Re: Response to Technical Comments – SPC Application D07-12-24-0087; 2900 Brian Coburn Blvd./119 Ryan Reynolds Way

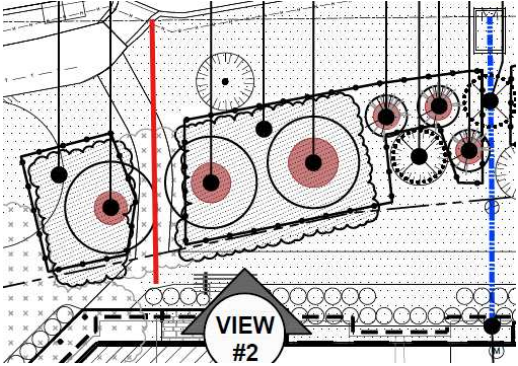
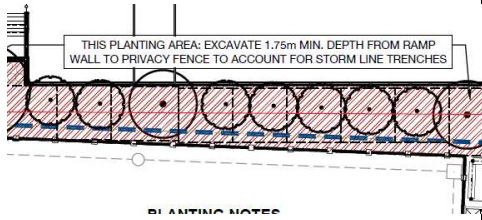
6. Tree # 10 is City owned. Removal would require justification. If justified, a permit and replacement planting is required. A white spruce would need to be planted as compensation. Please explain why the location of the watermain can not be moved? For	Please see revised Civil drawings and updated landscaping plan for the relocated watermain lines.

<p>example, placed under the walkway that connects pedestrians from Brian Coburn to the north west end of the building. Photo included for reference:</p> 	
<p>7. Tree 9 is also in close proximity to the watermain. Show the extent of excavation needed to install the watermain to confirm it does not conflict with the CRZ of this tree. Label the excavation distance from the watermain to the furthest extent of excavation.</p>	<p>Please see revised Landscaping plan. No ROW trees will be removed.</p>
<p>8. Please use an air spade instead of a hydrovac to excavate around retained City trees.</p>	<p>The plans have been revised. No excavation will be required.</p>
<p>9. There is a note on the Soil Volume Plan saying excavate 1.75m min. Depth from ramp wall to privacy fence to account for storm line trenches. At what depth are the storm line trenches? Has the engineering consultant confirmed there is no conflict with the proximity of these trees to the proposed storm pipe? Photo included for reference:</p> 	<p>There is no longer conflict with storm and trees as trees have been removed and replaced with native shrubs.</p>
